**RFQ 2024-113**

**GENERAL CONTRACTOR FOR ANIMAL SHELTER CONSTRUCTION**

## **ADDENDUM No. 2**

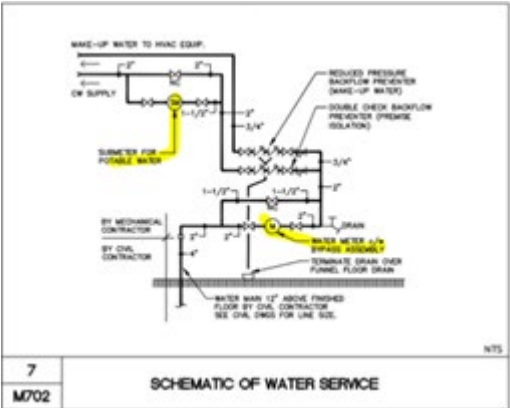
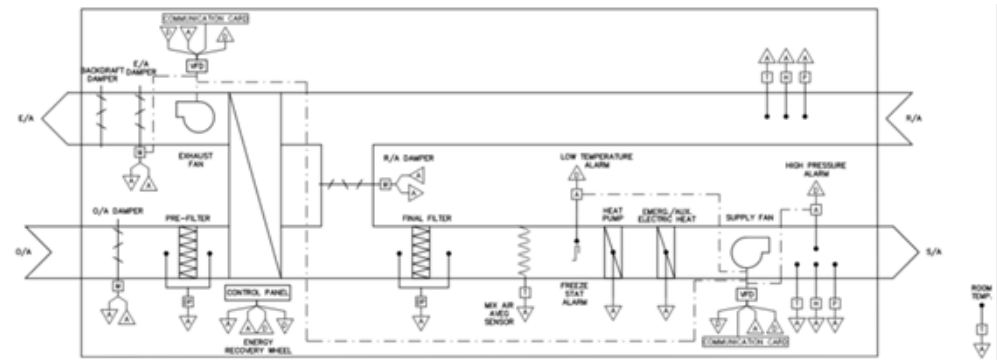
<b>Answer #60</b>	R10 rigid insulation is required under all frost slabs, typical.
<b>Question #61</b>	<p>Drawing A102 – Construction Note 14 states "digital information panel based on ***** by *****."</p> <p>It is located in Corridor 105 but is hatched as being N.I.C.</p> <p>Please confirm that the digital information panel is not in contract.</p>
<b>Answer #61</b>	Revise the digital information board in corridor 105 to be a T.V. (not in this contract) with power and data drops.
